# Modification Report (Mod 2)

## Sandy Hollow Solar Farm

March 2025

Project Number: 230554

Figure 2-1 Landscape Plan view of the landscape buffer and adjoining APZ configuration along the western site boundary (Moir, 2025)

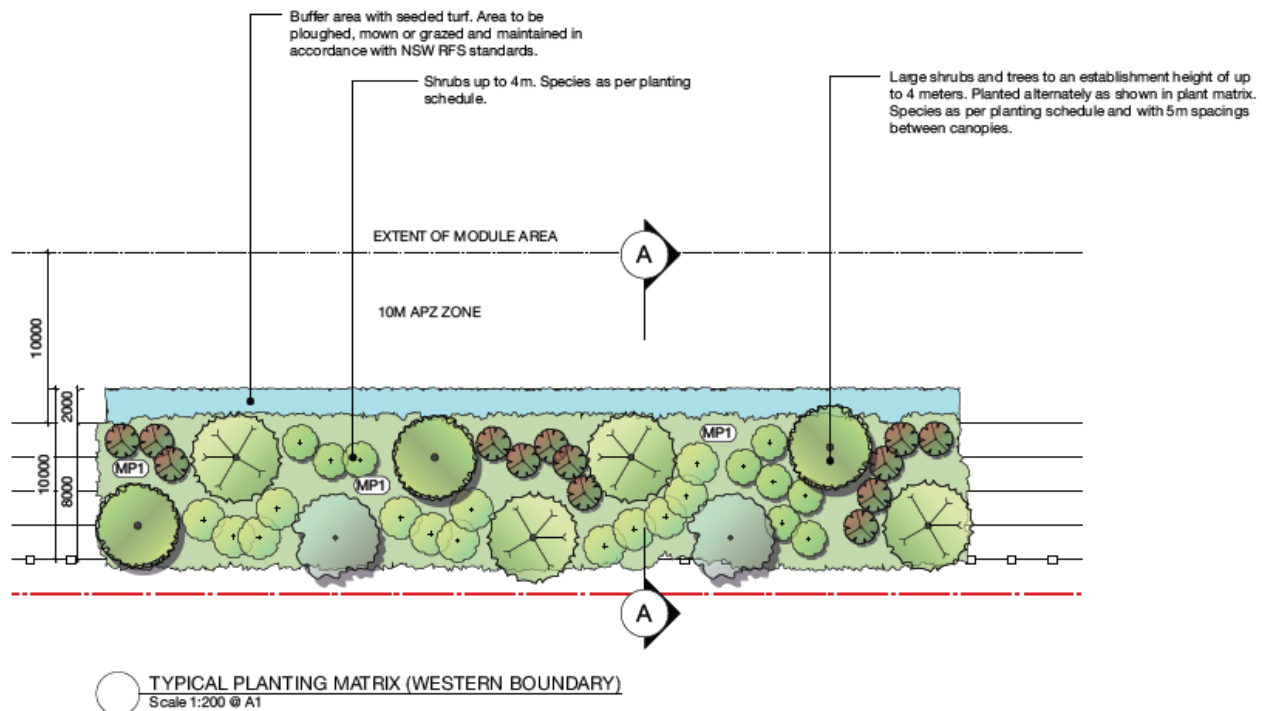
A 10m wide landscape buffer along the western property boundary would not be necessary (i.e. between the railway line and the Golden Highway). The proponent intends to provide a 10m wide landscape buffer along the western *site* boundary (i.e. along the western side of the solar array) as this would lie within the area leased to the proponent. A landscape buffer along the full extent of the western property boundary would

The 10m wide landscape buffer would consist of an 8m wide dense shrubby vegetation, supplemented by a 2m wide strip of managed turf. The 2m wide turf strip would be incorporated into the APZ, with 8m dedicated manicured APZ and 2m seeded turf to achieve a 10m cleared APZ in total. In total, there will be an 18m buffer from solar infrastructure to the security fence line. This is in line with the proposed landscape planning of the approved Denham Road Solar Farm.

- b) Identify a 10m wide landscape screen planting **for the length of solar panels** adjacent the western site boundary, **which may be partially incorporated into** the 10m wide asset protection zone (APZ) **as proposed**. The landscape screen planting is to be planted with both shrub and tree species to achieve screening from the ground level to a **height of 4m**. Where there is a conflict between this landscaping requirement and the location of solar panels marked on the approved plans, the landscape plan is to take precedence.

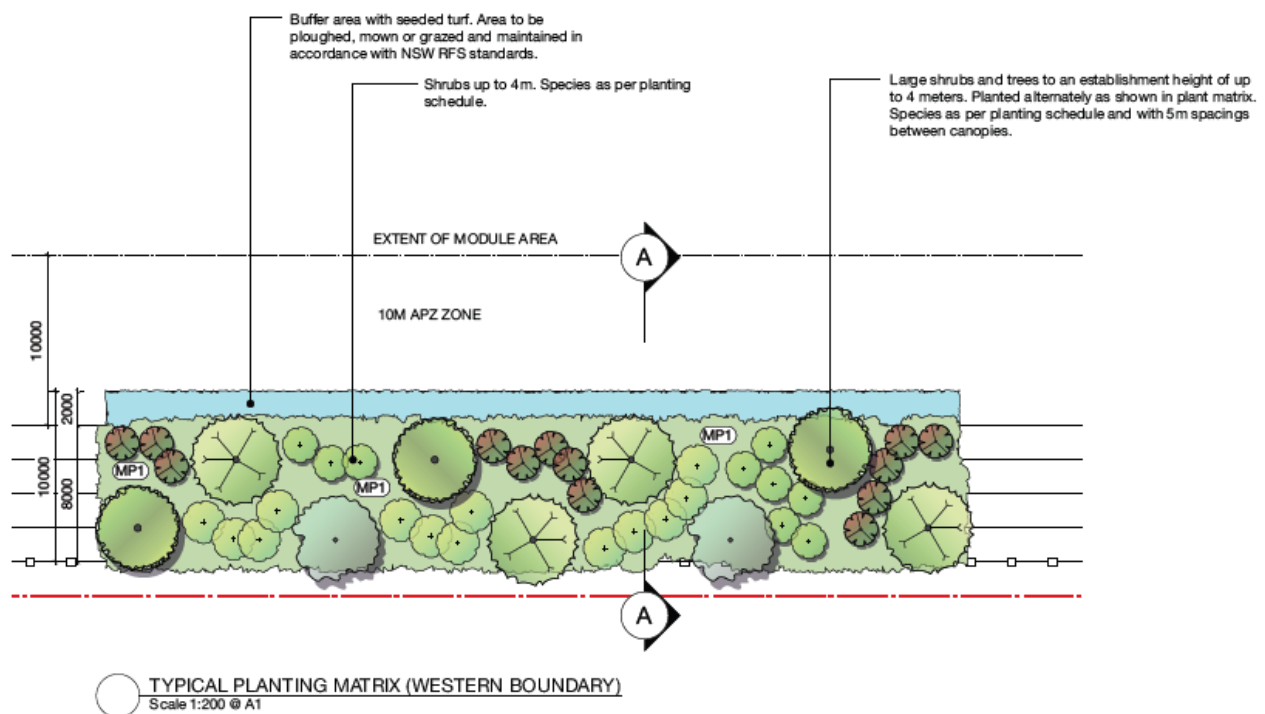
The proposed screening would be situated along the northern site boundary from the site access road to the site boundary fence. The proposed landscape screening would also be established along the western site boundary (i.e.) in line with the solar panels), refer to Figure 3-10.

The proposed landscape screening would be 8m wide, with a final established crown width of 10m, to achieve compliance with condition 6 (a). A supplementary 2m landscaping buffer area would be seeded turf and form part of the required 10m APZ. The buffer area is to be maintained as per NSW RFS standards. The APZ zone would be from the extent of the solar panels to the screen planting boundary (Figure 3-8)

Figure 3-9 Typical screening along site boundary (Moir, 2025)

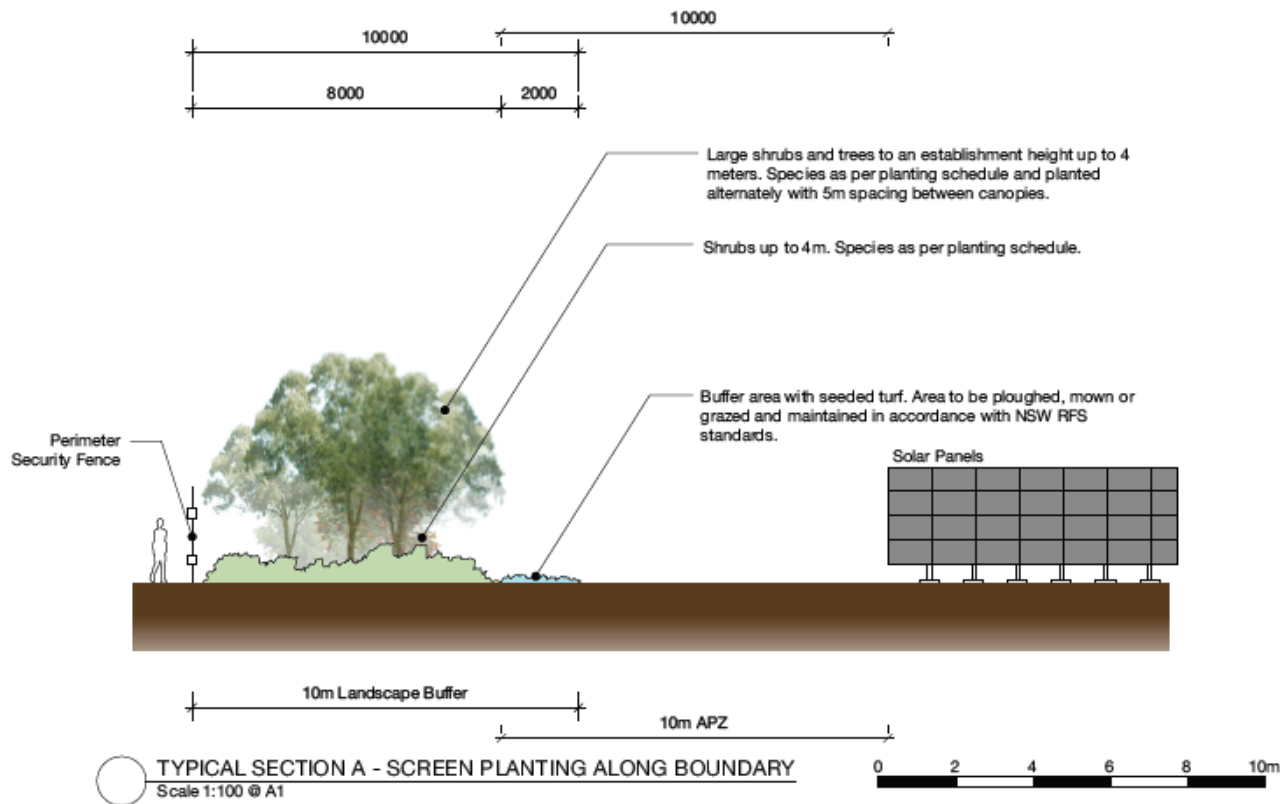
The proposed screening would comprise of shrubs and small trees, maintained to an established height of up to 4m. The selected trees and shrubs would be planted alternatively as illustrated in the planting matrix of the Landscape Plan (Appendix D), with a 5m spacing between canopies (Figure 3-9).

- c) Identify **5m wide** landscape screen planting along the **northern site boundary**. The landscape screen planting is to be planted with both shrub and tree species to achieve screening from the ground level to a **height of 4m**.
